Deemed Provisions – Cl 67 Matters to be considered by local Government

Comment:Town Planning Scheme No. 2 (TPS2)

Figure 6: Existing and proposed road network

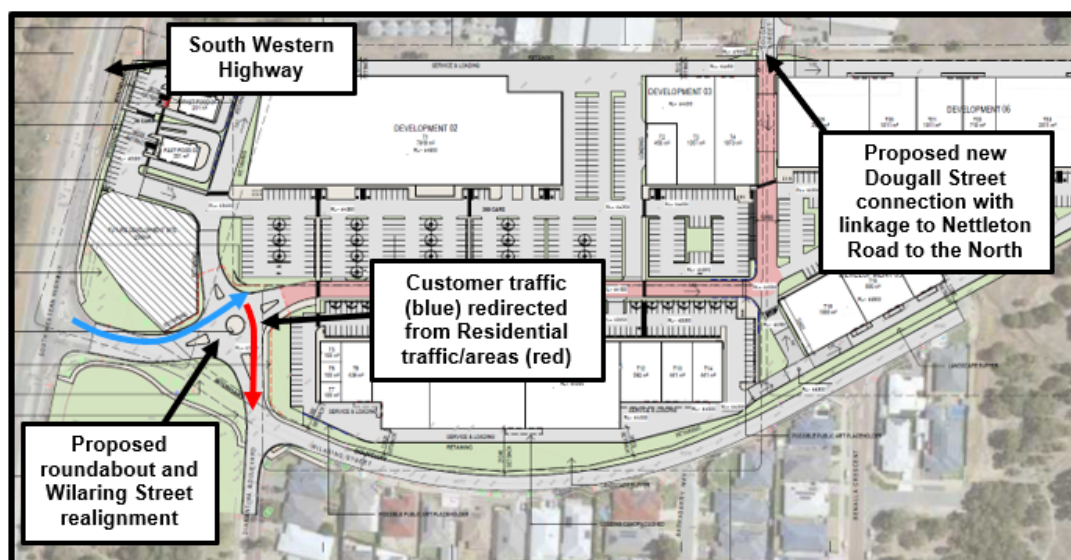
As a due regard document, the proposal differs from the LSP through the realignment of Wilaring Street and also the modified landscaping provision.

In terms of realigning Wilaring Street, access to the site via Wilaring Street had not been contemplated by the LSP, with the focus in isolating vehicle movements to the north via Dougall Street. Officers consider however, the realignment to still achieve the intent of the LSP as it has been realigned to deviate traffic away from the residential development to the south, while also maintaining the access to the site via Dougall street. The alignment will ultimately separate the traffic associated with the commercial development from the residences, removing the risk of increased traffic on a residential road. This is shown in the figure following:

Figure 7: MRWA suggested treatments to ensure safety of South Western Highway/ Wilaring Street intersection

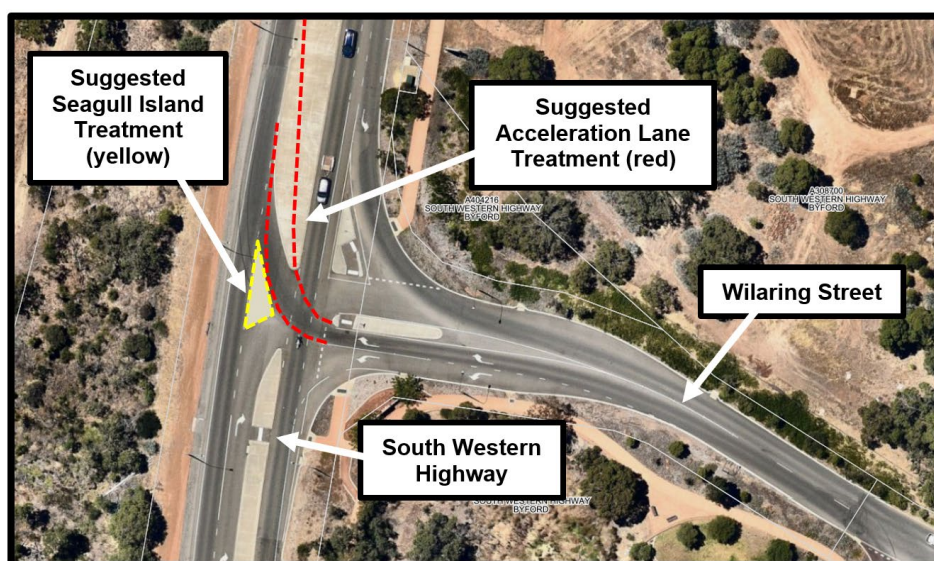
The intersection can only manage one north bound vehicle at a time in the median strip waiting to access South Western Highway resulting in the queuing. The TIA states that queuing would extend approximately 60-70% beyond Wilaring Street, east of South Western Highway towards the proposed roundabout. Officers consider that the queuing is also likely to be higher as the SIDRA analysis does contemplate the residential vehicles of the Scarp using the same South Western Highway/Wilaring Street entry points. Officers consider that to address queuing and to alleviate congestion along Wilaring Street that may also impact upon internal movements of the site, an island treatment and an acceleration lane treatment is required, based on the specifications of MRWA. This has also been recommended by MRWA These can be viewed following:

The island and acceleration lane treatments would enable a clear and continuous movement path across South Western Highway for vehicles, reducing queuing along Wilaring Street. The treatments would ultimately reduce the extent of queuing and congestion along Wilaring Street and improve the safety of the intersection. As such, a condition has been recommended to this effect. A further condition will be recommended to require service vehicles to utilise the Dougall Street entry and exit to the site to further reduce queuing along Wilaring Road. The costs of these treatments would be the responsibility of the applicant.

Figure 8: Tonkin Highway extension (red), South Western Highway (yellow)

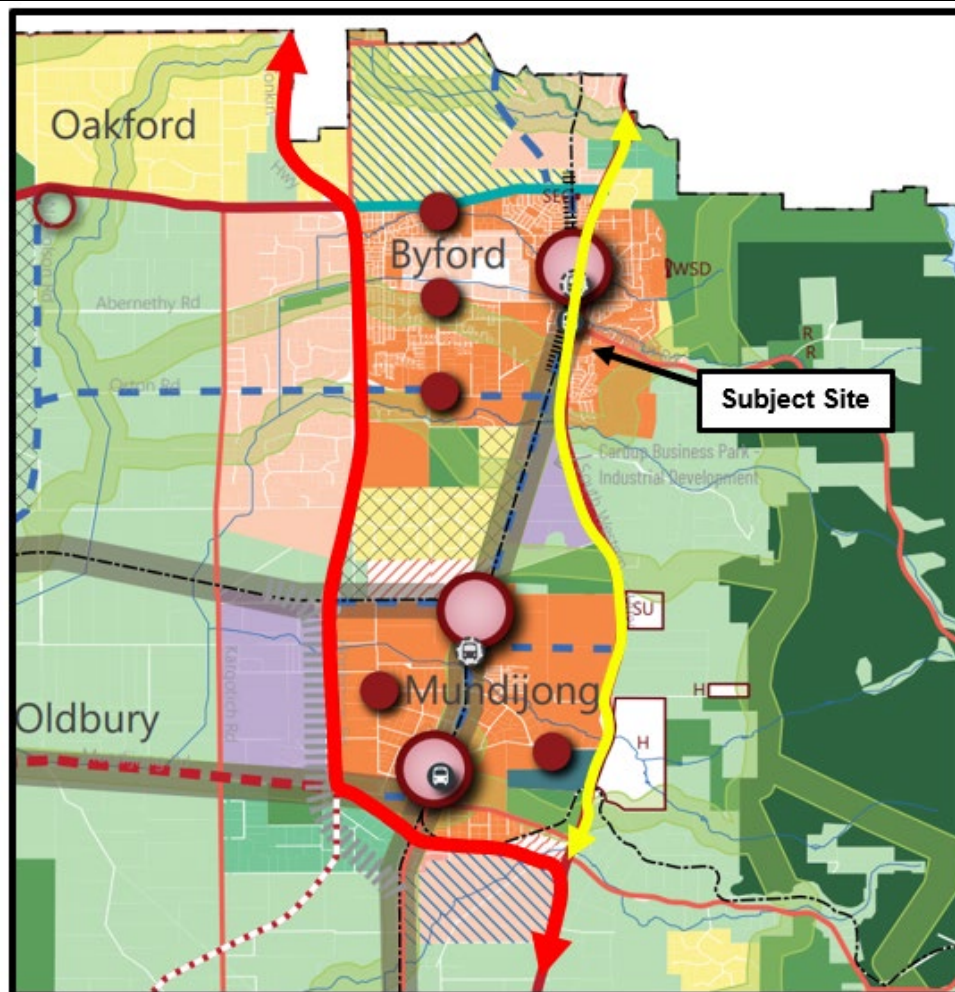
MRWA as part of their submission provided comments (as detailed previously) recommending that the TIA be amended to model for future projected increases to background traffic. Traffic along South Western Highway is likely to be significantly reduced as part of the Tonkin Highway extension. This will create a new key north-south linkage which is displayed in the following figure. Thereby, the growth projections would likely indicate that there would be less north-south bound traffic on South Western Highway. This would ensure the adequacy of the nearby road network to cater for the proposed traffic associated with this development, as well as future increases.

Figure 9: Proposed additions to local road network, including four-way intersection

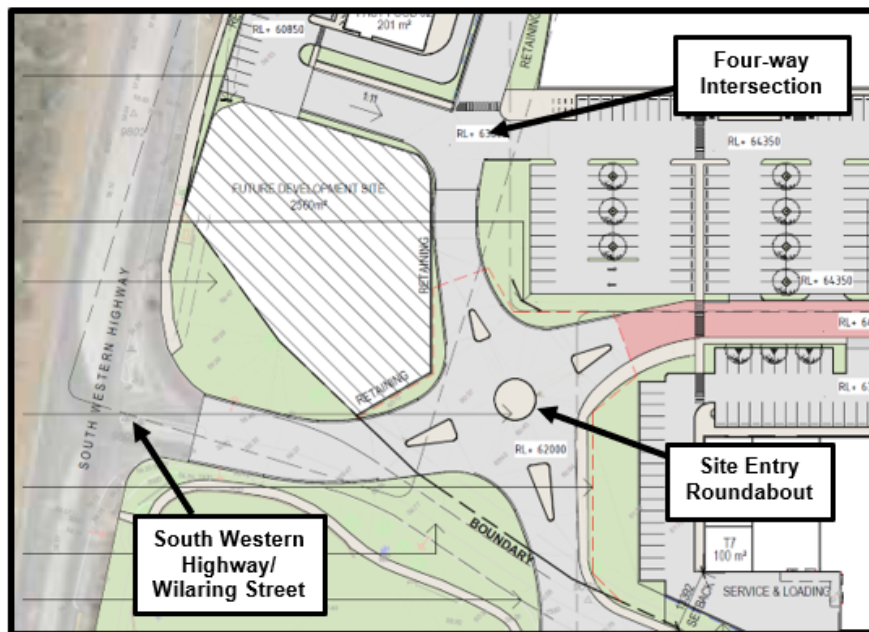
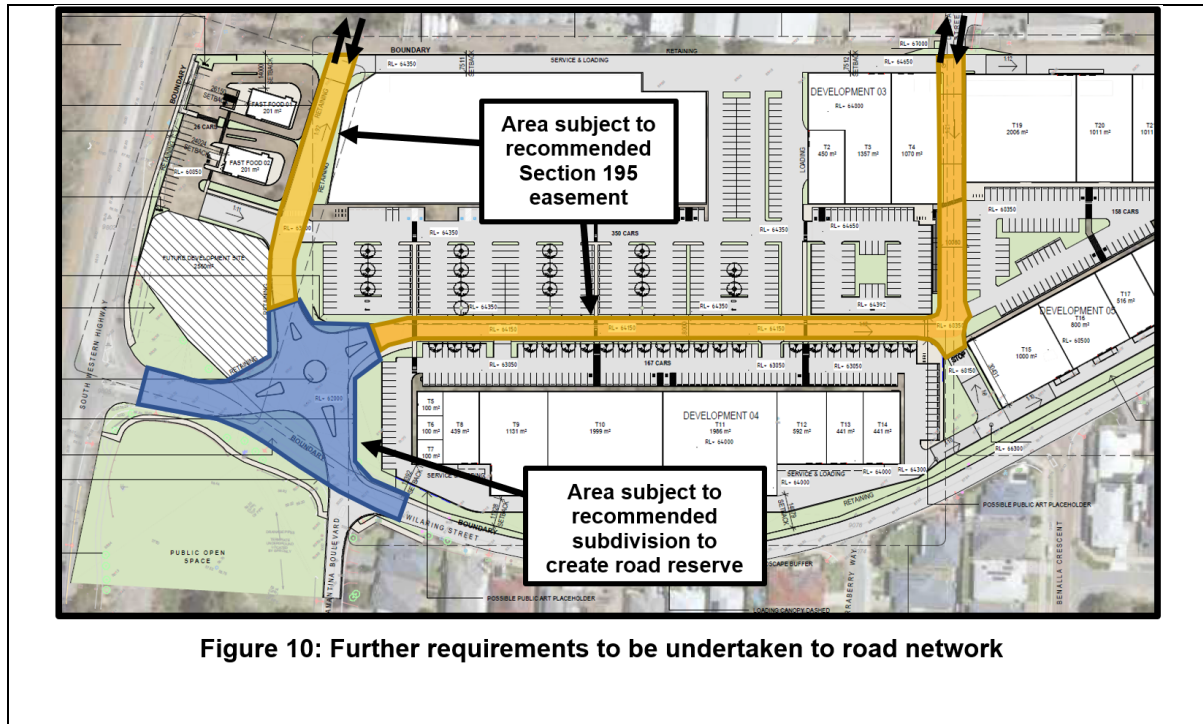
Another matter raised in the MRWA referral was relating to the efficiency and safety of the internal four-way intersection to the north of the roundabout, potentially leading to queuing onto South Western Highway. The four-way intersection is viewed following:

MRWA have indicated that due to the irregular shape of this four-way intersection and that the crossovers are different in size, that it may cause confusion for customers resulting in queuing. MRWA recommends the installation of a smaller roundabout at this location, which Officers consider would ensure efficient and safe flow of traffic internally to the site. This measure has been recommended as a condition of determination.
